**CITY OF TEMPE
DEVELOPMENT REVIEW COMMISSION**

**Meeting Date: 02/11/2014
Agenda Item: 4**

ACTION: Request for a Use Permit to allow Tandem Parking and a Development Plan Review consisting of a new 33 unit multi-family development for JENTILLY LANE CONDOMINIUMS, located at 1717 South Jen Tilly Lane. The applicant is Trapezium Consulting.

First Floor
273 Sq. Ft.

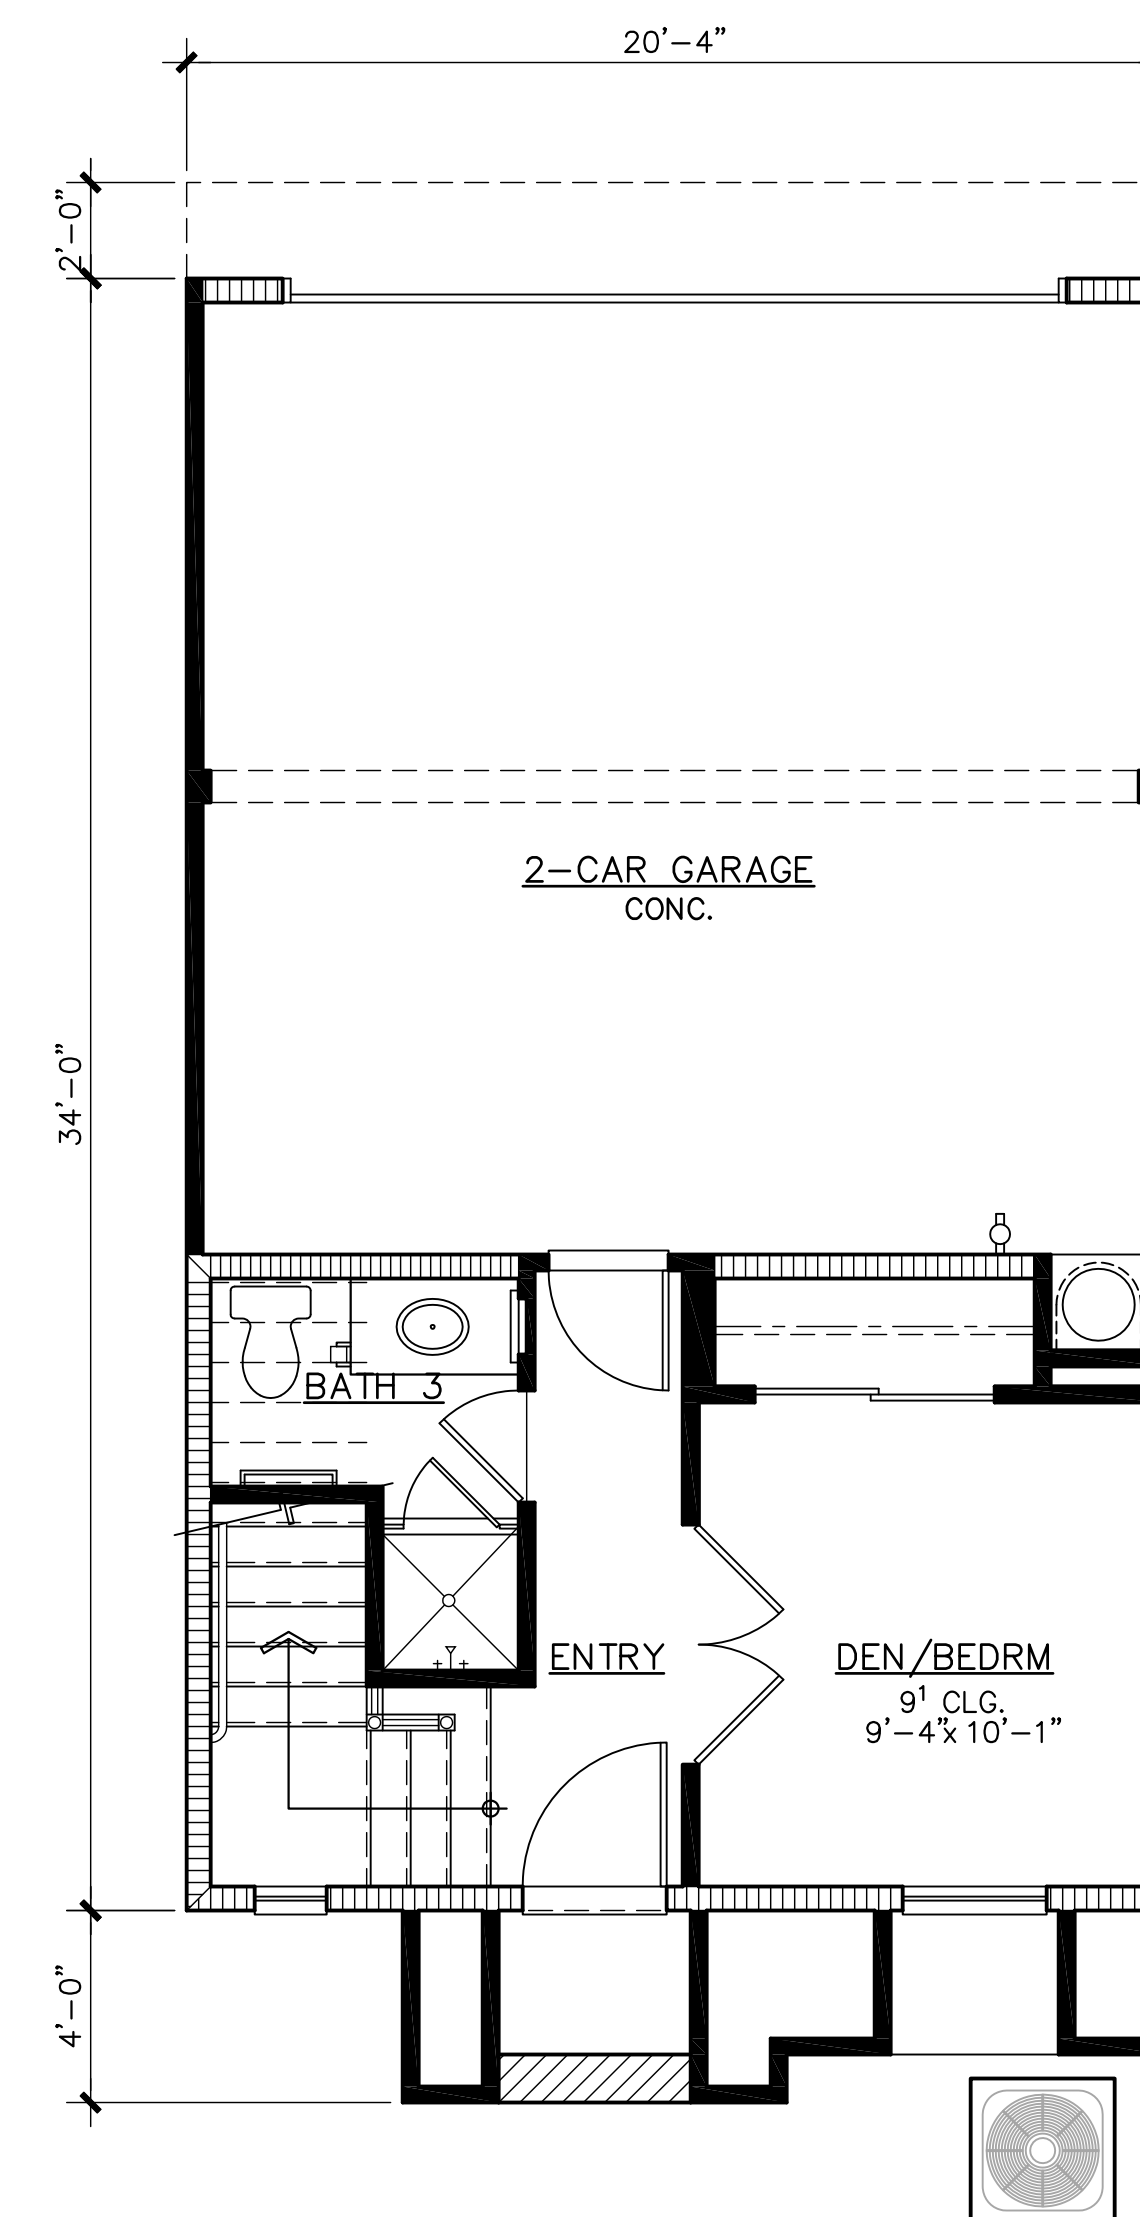
7. Flexible rooms shown on floor plans of Unit 2 designs shall be counted as bedrooms in the calculation of the required number of parking spaces.

3-Story Elevations

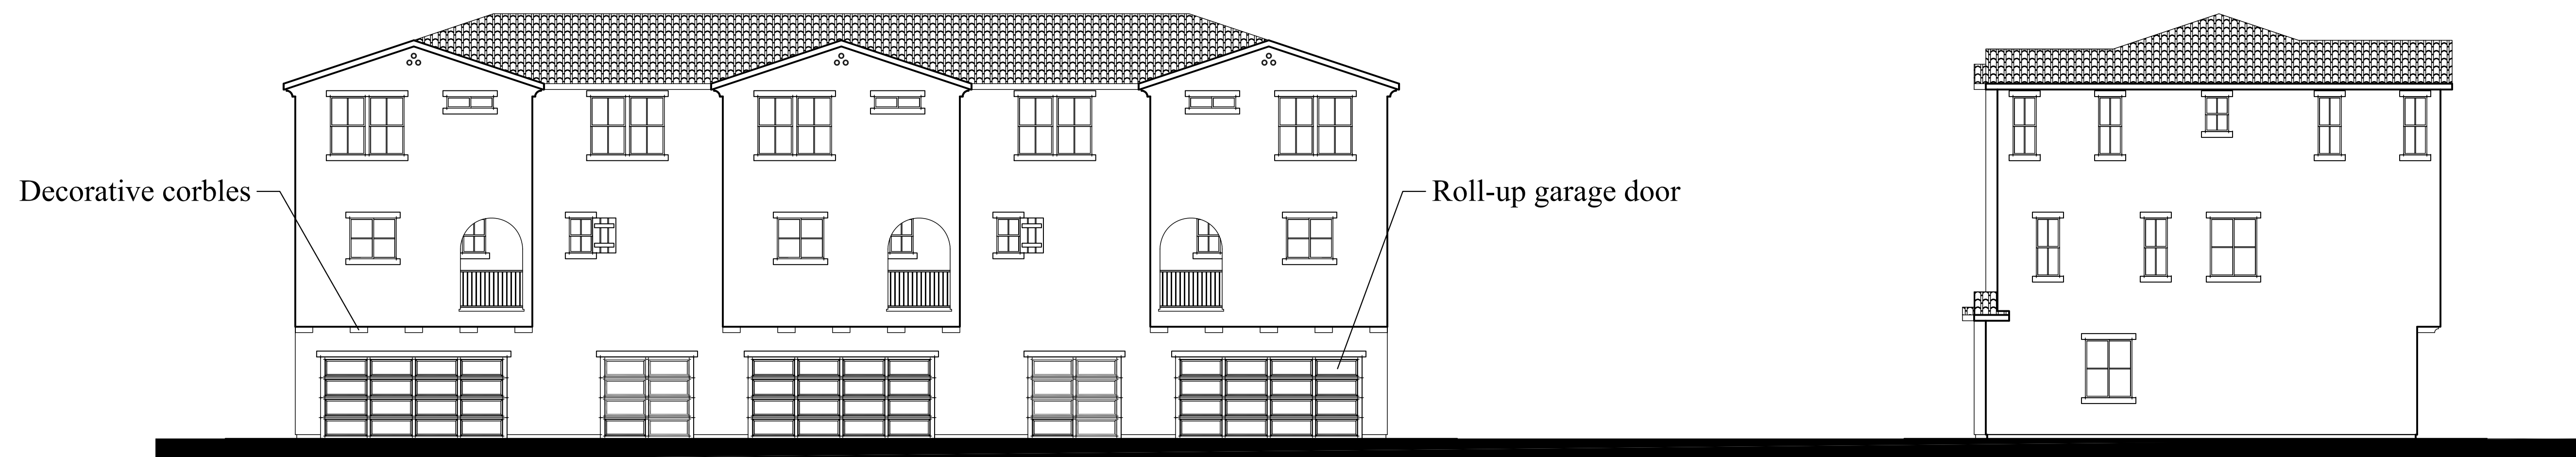
8. The colors and materials exhibited on the colored elevations are conceptually approved as provided. Submit specific color and material information on construction documents for review during building plan check process. Planning inspection staff will field verify colors and materials during the construction phase.

The main colors and materials shall not exceed light reflectance value of 75 percent.

9. Provide rain gutters to convey water off roof and away from pedestrian walkways and entrances. Roof areas that do not directly affect walkways and entrances are not required to be guttered. Incorporate gutters into elevations and conceal downspouts to enhance the character of the residences.
10. Incorporate lighting, address signs, incidental equipment attachments (alarm klaxons, security cameras, etc.) where exposed into the design of the building elevations so that the architecture is enhanced by these elements.
11. All transformer boxes, meter panels and electrical equipment, backflow valves, and other utility equipment shall be painted to match the adjacent building color.
12. Exposed conduit, piping, etc. is not allowed unless a creative conduit surface design that compliments the architecture is reviewed and approved by the Development Review Commission.

PRELIMINARY LANDSCAPE PLAN

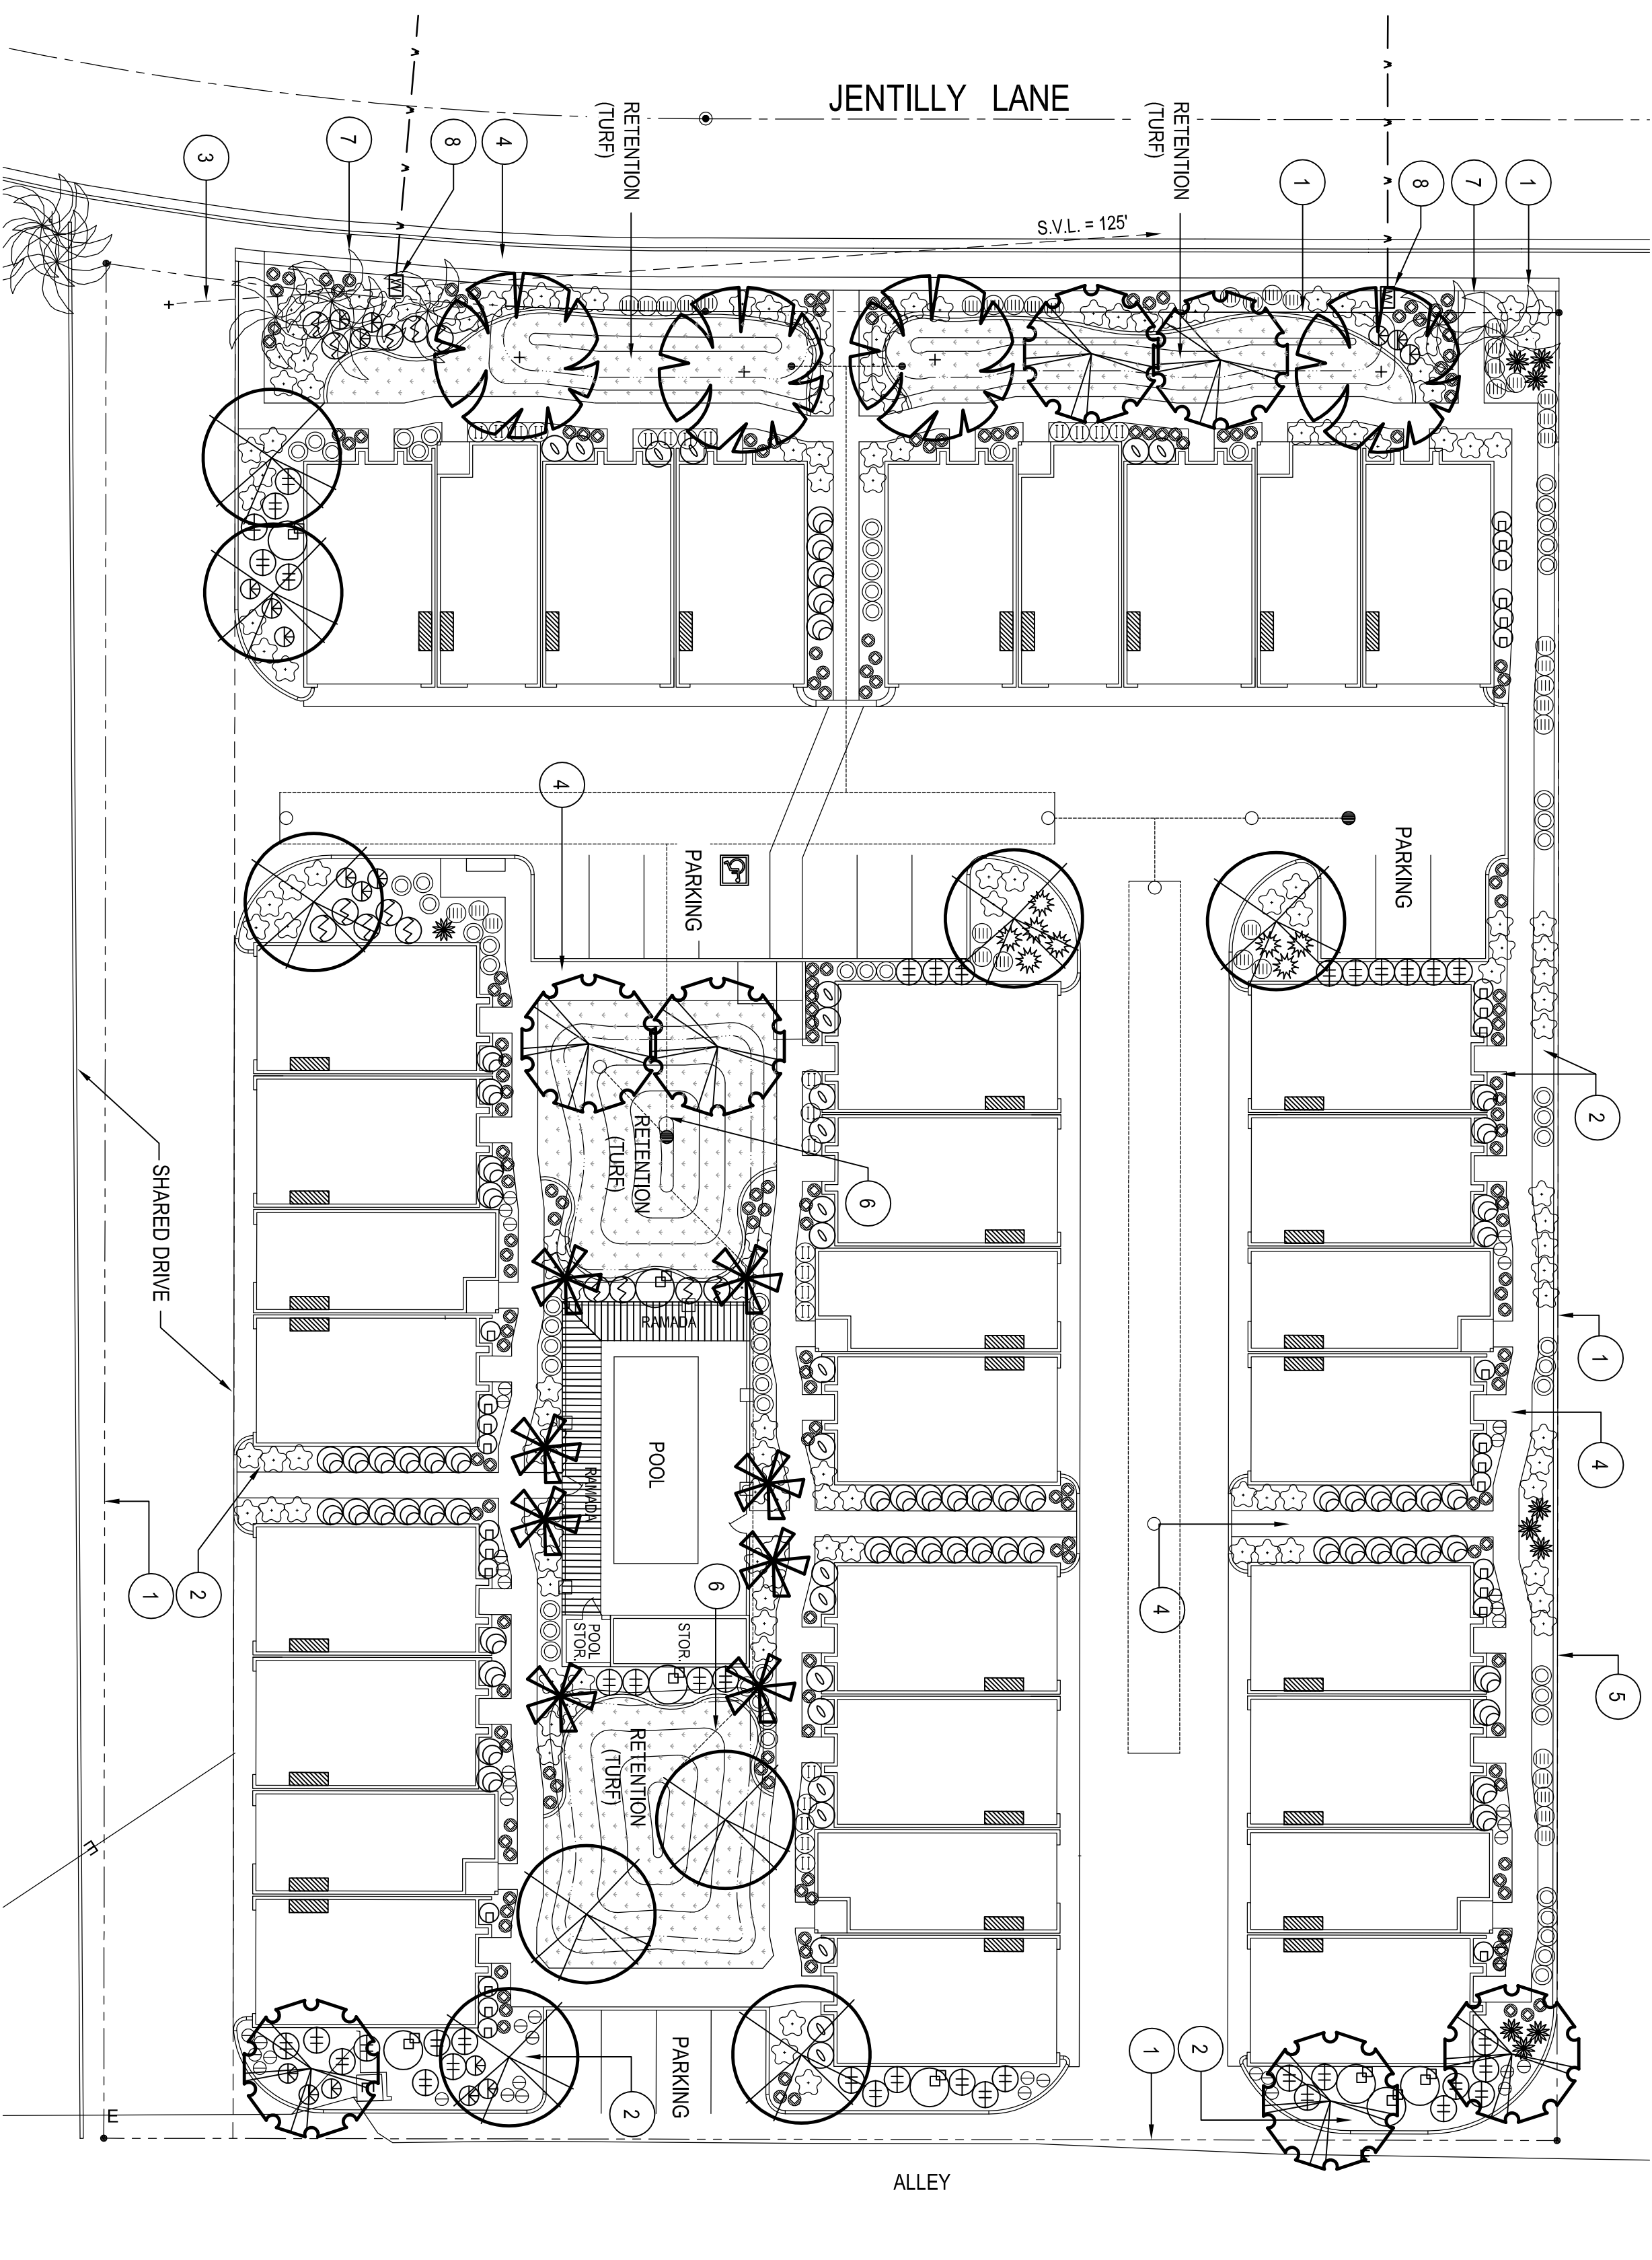
15. Top dress planting areas with a rock or decomposed granite application. Provide rock or decomposed granite of 2" uniform thickness or less. Provide pre-emergence weed control application and do not underlay rock or decomposed granite application with plastic.
